Technical Service Bulletin

****For additional information, refer to Ford bulletin #95-4-9.***

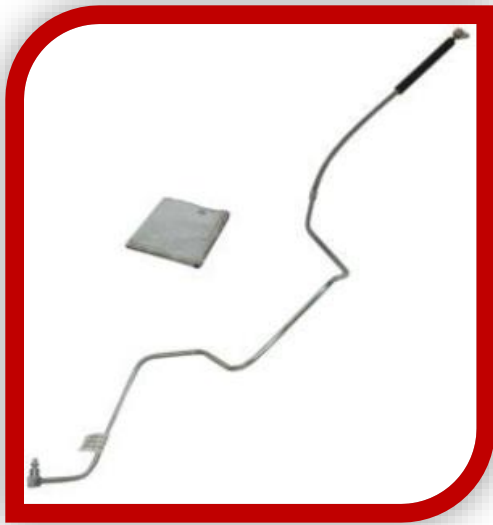
Referenced vehicles were prone to no release, caused by a defective hydraulic release system. To eliminate leaks that may cause this condition, install an upgraded master cylinder and slave cylinder. These components must be installed together. Contact your distributor for specific part numbers.

A new tube kit, Ford part #F5TZ-7A512-A, and pedal pivot shaft lever, Ford part #E7T2-7A554-A, must be used with the upgraded parts.

Ford part #F5TZ-7A512-A

Ford part #E7T2-7A554-A
